ORDINANCE NUMBER 2016-09

**AN ORDINANCE OF THE TOWN OF PARADISE VALLEY,
ARIZONA AMENDING THE PARADISE VALLEY ZONING
ORDINANCE, Article XXII, HILLSIDE DEVELOPMENT
REGULATIONS**

Section 1. Article XXII, Hillside Development Regulations, Section 2200- 2209 are hereby amended (with deletions shown as ~~strikethroughs~~ and additions shown in **bold type**):

FIGURE 3 – PRIMARY RIDGE LINE DESIGNATION

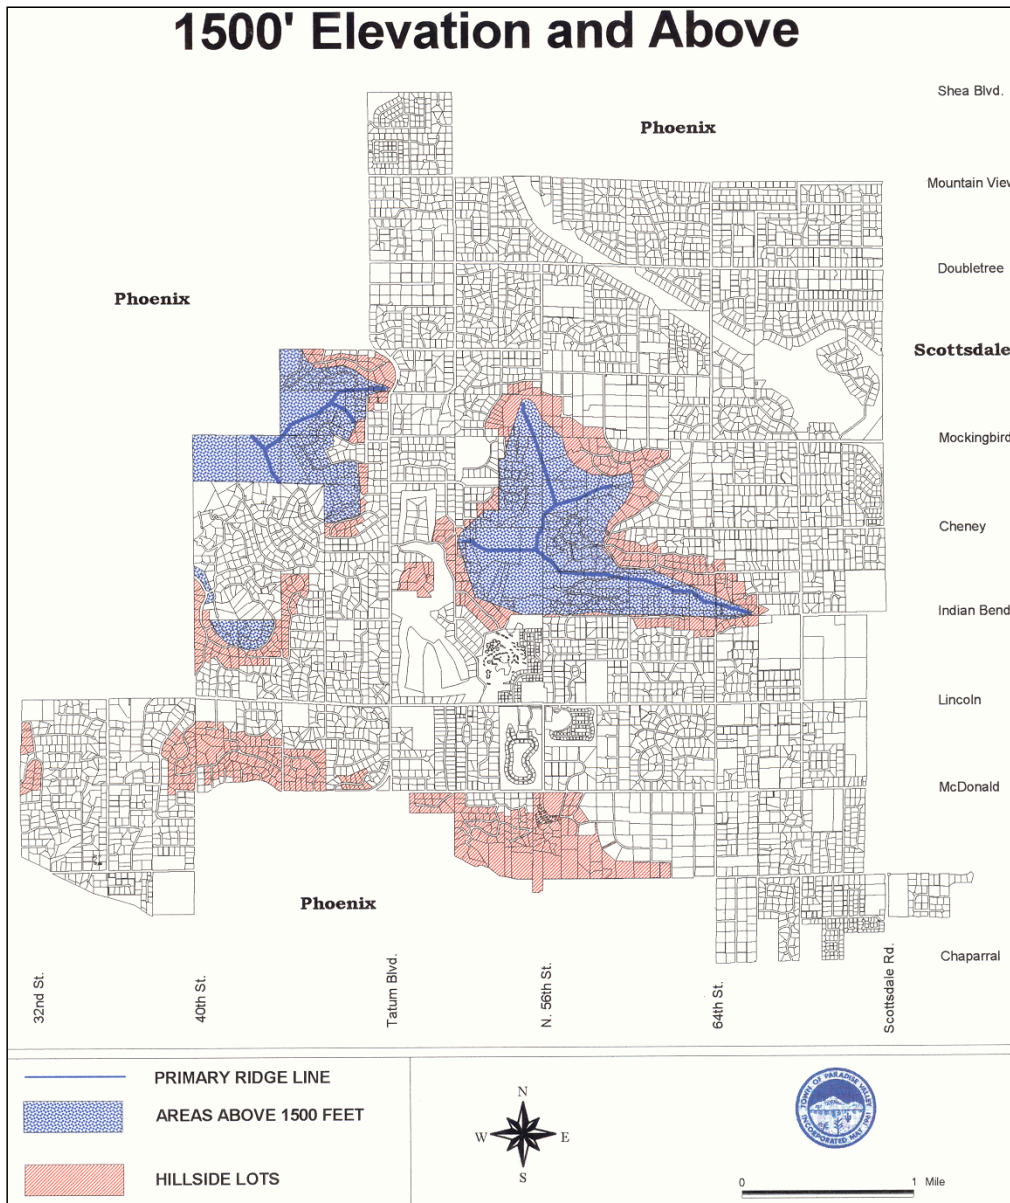
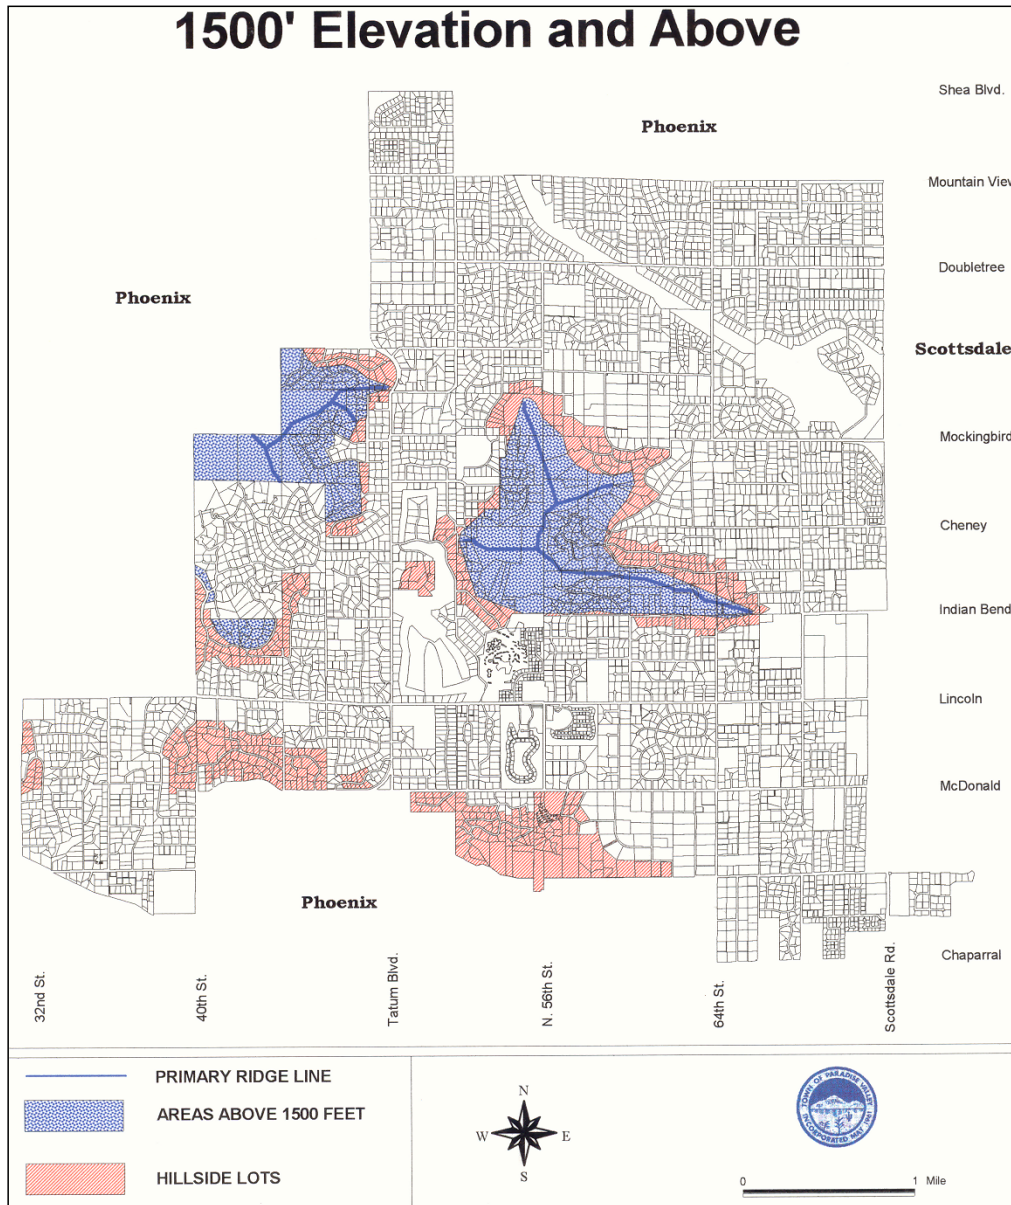
Commented [GB1]: Figure 3 Moved after Definition Section on Page 9

FIGURE 5 – BUILDING HEIGHT IN HILLSIDE

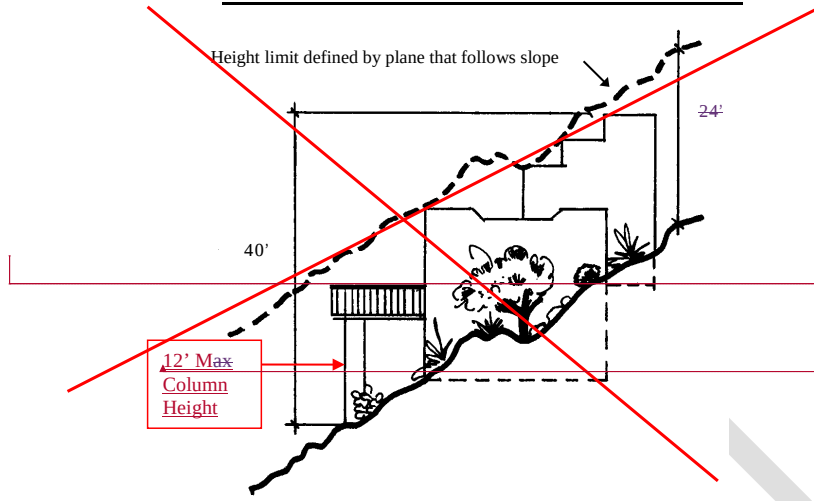
Commented [GB4]: Figure 5 to be updated to reflect these edits.

Commented [GB5]: Update Figure 5 to clarify measurement of 40' maximum height limit.

- iii.3. The maximum overall height of the building or structure, including chimneys and accessory buildings, shall not exceed forty (40) feet from the highest point of the building to natural grade at the lowest point adjacent to the building structure or column of a building or structure to the lowest point of Natural Grade at the lowest building or structure (excluding driveway/retaining walls) (see FIGURE 5).

FIGURE 7 - HEIGHT FOR A CANTILEVERED ELEMENT

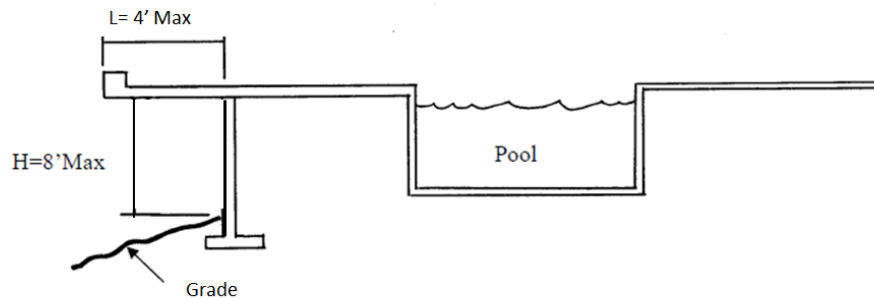
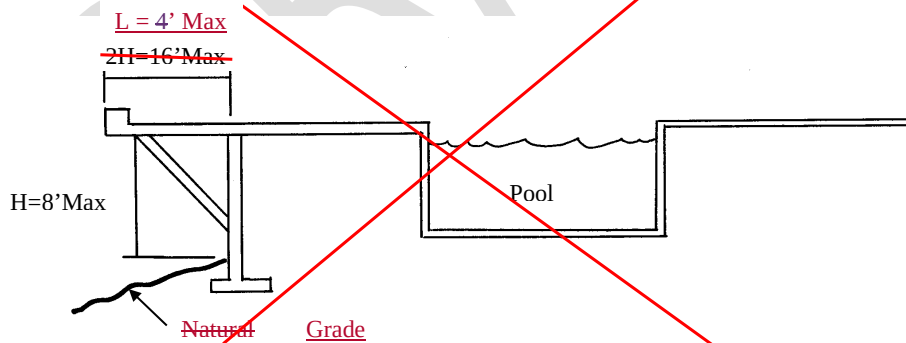
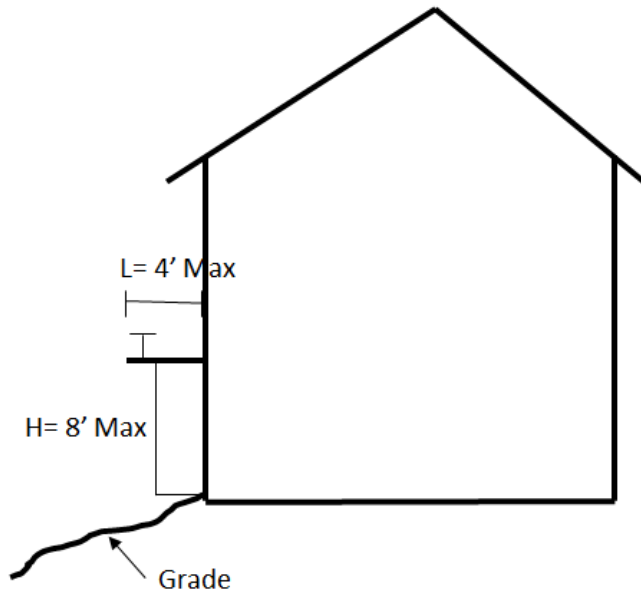
Commented [GB6]: New figures to be added to the code to illustrate these scenarios.

Commented [GB7]: Remove support from illustration and change horizontal to 4' max on Figure 7.

2. All other structures (such as pool decks). Cantilevered elements of the structure must comply with the applicable setbacks and heights of the structure. Structures employing the use of a cantilever Cantilever may extend the cantilever Cantilever a maximum horizontal length of 4 feet and a maximum vertical height of 8 feet from adjoining grade. All of the area underneath the cantilever Cantilevered element shall be calculated as disturbed area Disturbed Area and shall be included in the disturbed area Disturbed Area calculation. (See FIGURE 7).

FIGURE 8 –TERRACED VERTICAL RETAINING WALLS

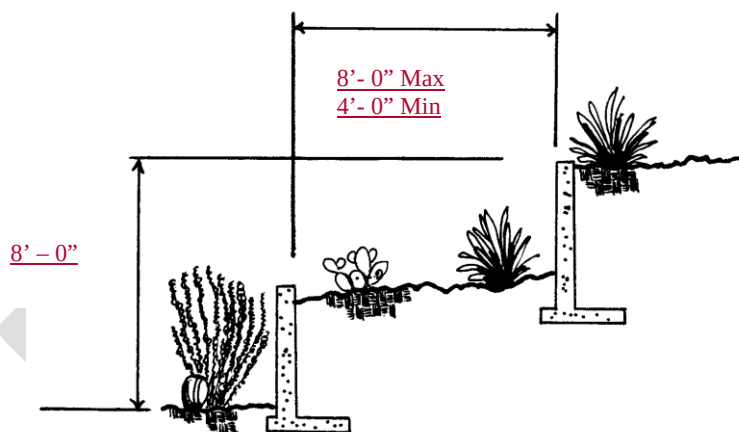
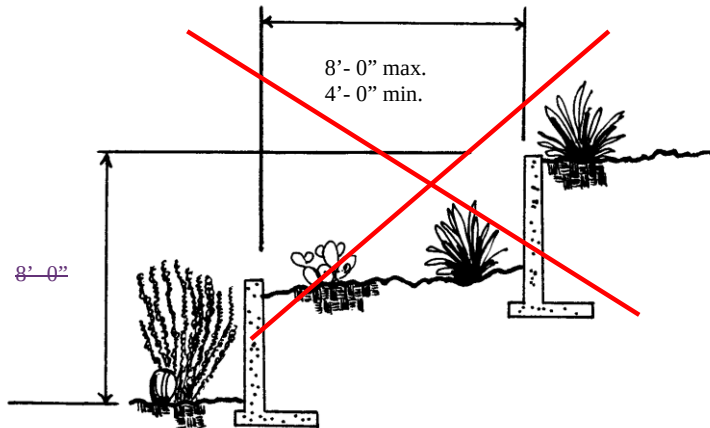
Commented [GB10]: Relocate Figure 8 below the text of 2207.VI.1.e.
